**Part: SE141-114 / MODULAR COIL WINDING FORM TYPE**

Drawing ID: MCWF TYPE-A XRAY MA Revision: 1  
W/O Links: 1-Type:W: 65709/5.0 Sub: 1

**Problem: X RAY FAILURE ON:**

## NC21264 – RT Rejections

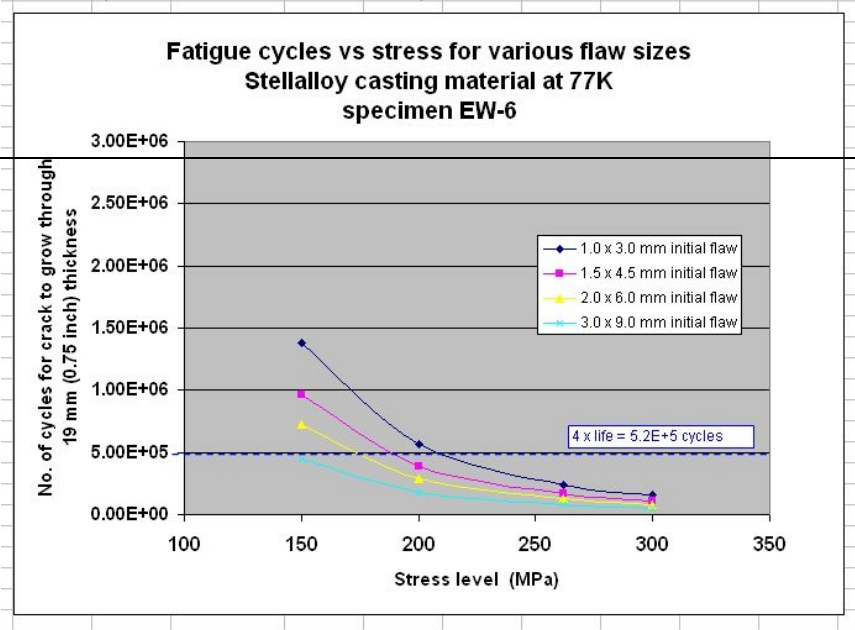
"T AREA", VIEW 41-45, POROSITY CLUSTER, LARGEST PORE MEASURES .090", AVERAGE PORE SIZE .060". APPROX. 15 PORES IN A 1 INCH CIRCLE. LOCATED BETWEEN TAPPED HOLE 43 AND 44. STRING OF POROSITY LEADING OFF OF CLUSTER APPROX. 4 INCHES.  
(see attachment)

**Customer Disposition:**    ☒ Use As Is    ☐ Rework    ☐ Repair    ☐ Scrap    ☐ Replace

The attached RT indications were reviewed by D. Williamson and discussed during a conference call attended by J. Chrzanowski, L. Sutton, F. Malinowski, L. Dudek, D. Williamson, T. Brown, and P. Heitzenroeder on 2/28/07. Dave notes that the stress in this region varies from 9-20 ksi. (62-138 MPa). As can be seen in the fracture plot, the region will meet the fatigue life criteria with these flaw sizes. (max. size is 0.090" : 1.5 mm)

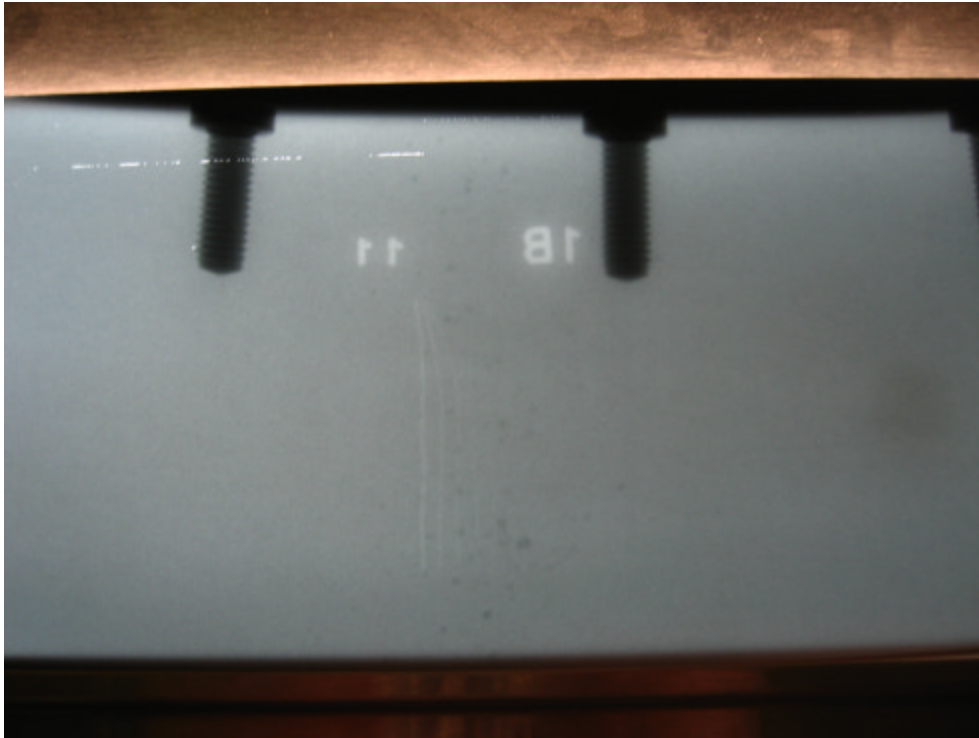
View above is of a cluster of porosity between holes 43 and 44. The largest was sized at approximately .090”.
